April 16, 1981

Re: Letter to State Engineer

Project No. RM80-311

Results of Phreatic Level Study for Resolution of Beach Width Question

FIGURE 1

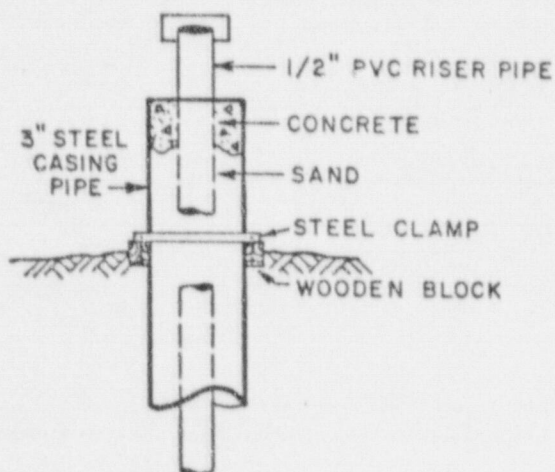
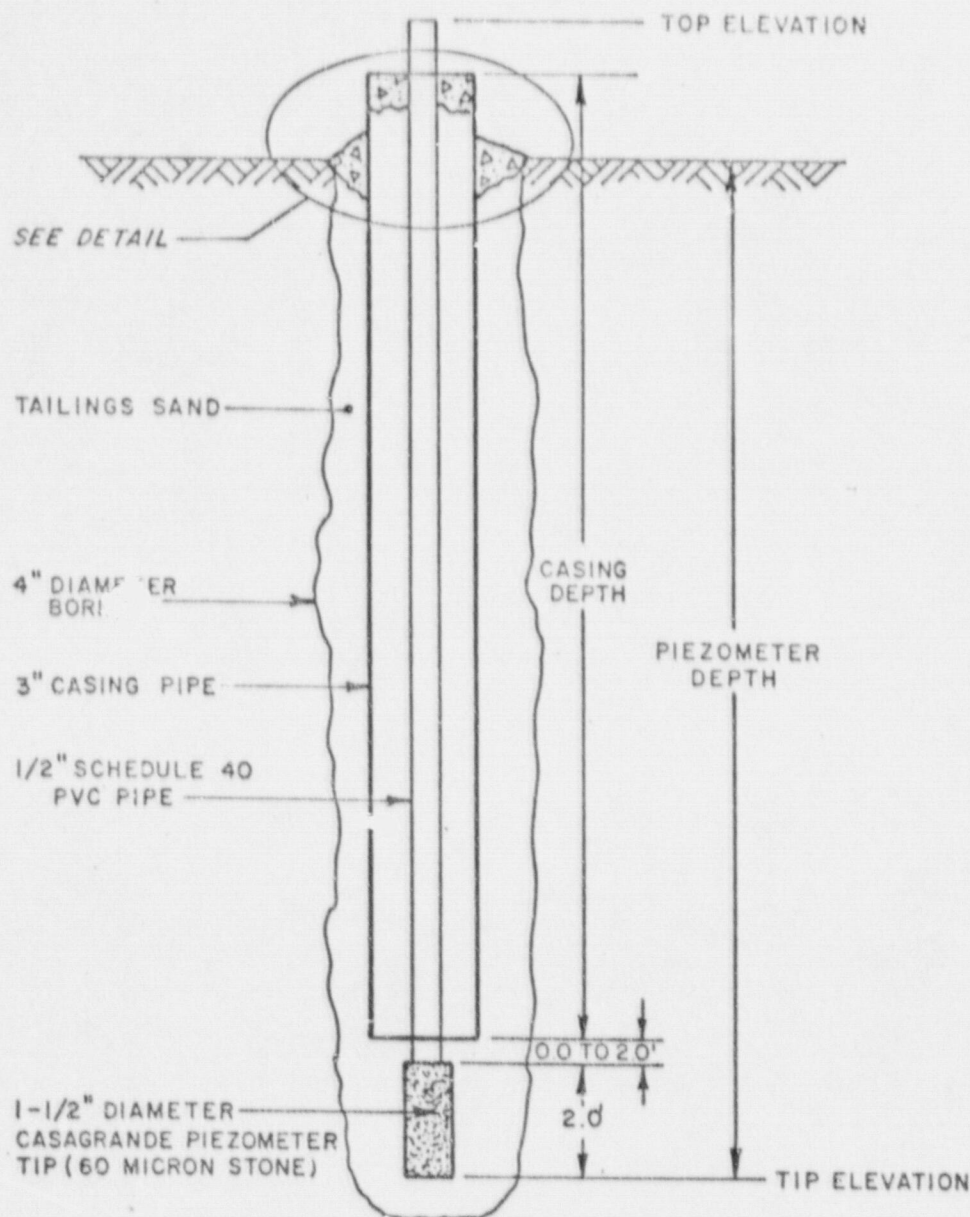
The installation of the Casagrande piezometers was made by drilling a four-inch diameter hole with compressed air. The drilling was performed by Homestake personnel using their trailer mounted rotary rig and a portable air compressor. When the boring reached the designated depth the drill rod was removed and a 3 inch steel pipe was placed into the hole to prevent caving during piezometer installation. The steel casing was held above the designated sensing zone by the use of the clamp and blocking configuration shown on the typical installation diagram, Figure 1. Compressed air was used to create a pocket below the steel casing for insertion of the Casagrande piezometer. The Casagrande piezometer was then mounted to 1/2 inch schedule 40 PVC pipe and placed with the tip at least two feet below the steel casing. Once the Casagrande piezometer was in place the annulus between the PVC riser pipe and the steel casing was backfilled with tailings sand and cemented with Portland cement around the top to prevent infiltration of surface water. The annulus around the outside of the steel casing was also backfilled with tailings sand and cemented with Portland cement at the ground surface to provide protective rigidity to the PVC riser pipe. Finally, the piezometer number was labeled on the protective steel casing and the piezometer cap.
